Glider model:

Subject: Elevator.

Technical Note  
for  
Glider Models as per Sheet 1

Alexander Schleicher  
GmbH & Co.  
Segelflugzeugbau  
D-6416 Poppenhausen

Fig.1

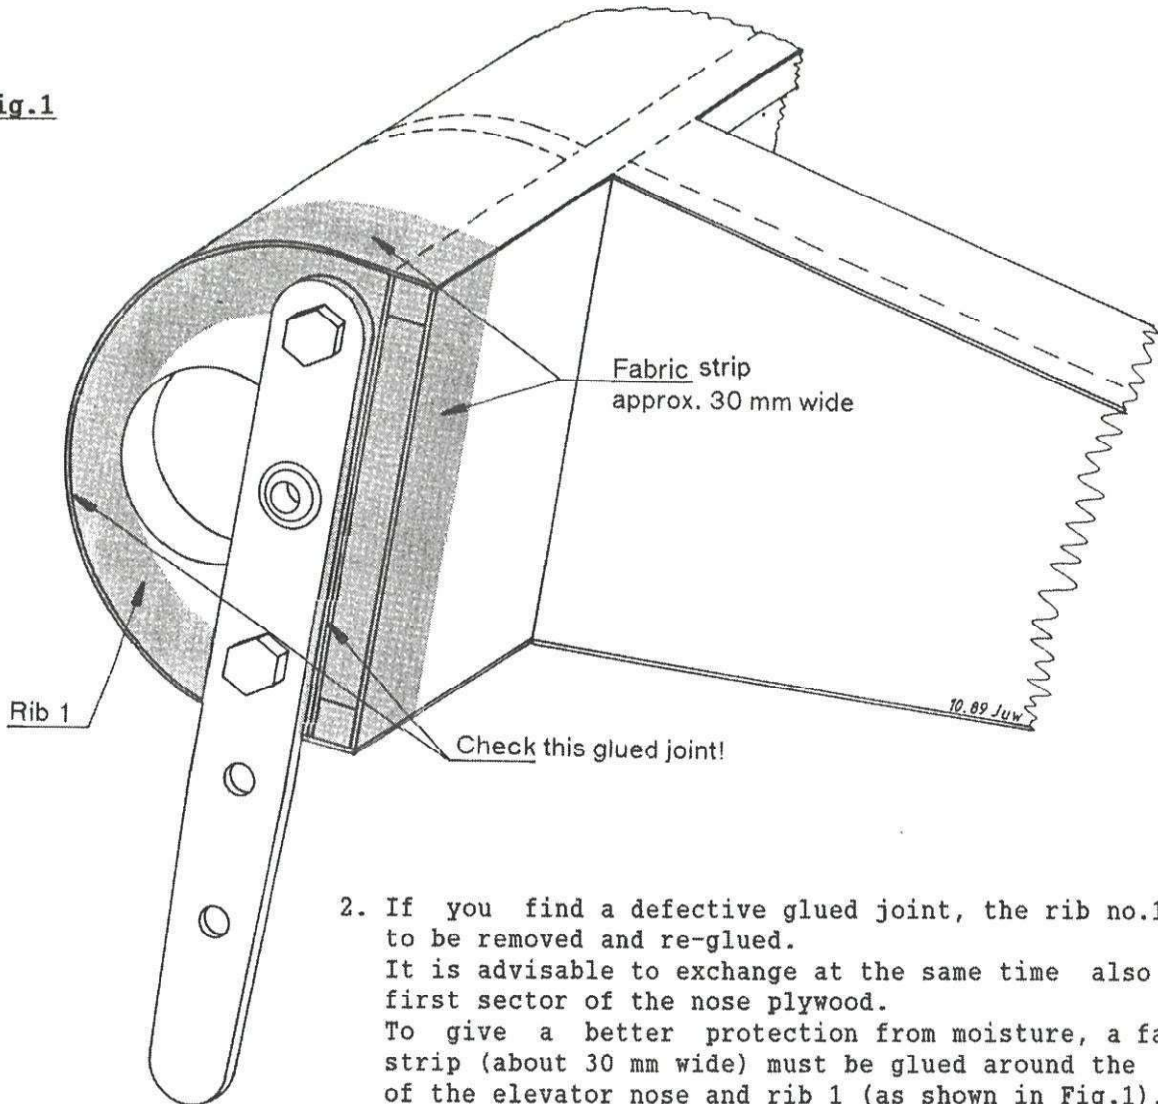
Reason: A glider of the model K7 failed to gain normal flight attitude immediately after tow rope release on winch launch. With the stick full back only the left elevator could be actuated in the correct direction; the right elevator deflected downwards. The reason for this was a loose glue bond at the elevator rib 1 at which the elevator fitting is attached. Similar incidents lead already before to the issue of the LTA 72-7 dated Feb.9,1972.

1. Remove elevator.  
Check that the glued joint between rib 1 and the leading edge plywood and the elevator spar respectively is in good condition (see Fig.1). Before doing so check whether the LTA 72-7 of Feb.9, 1972 was already previously accomplished (this is not applicable to K9, K11 and ASK 18); if yes then the fabric strip first carefully has to be detached in order to be able to check the glued joint.

- 
2. If you find a defective glued joint, the rib no.1 has to be removed and re-glued.  
It is advisable to exchange at the same time also the first sector of the nose plywood.  
To give a better protection from moisture, a fabric strip (about 30 mm wide) must be glued around the edge of the elevator nose and rib 1 (as shown in Fig.1).
3. The above action under points 1. and 2. must be repeated every three years during the annual re-inspection.  
This copy of the Technical Note must be inserted in the Flight and Operations Manual of the respective glider as an annex and a corresponding entry must be made into the "Amendments to the Manual".

Rib 1 made from multi-plywood, 15 m thick, and nose plywood, 1 mm thick, according to DIN L 182/183, class 1/2 or NL 9128, 6.1013. Drawing as above.
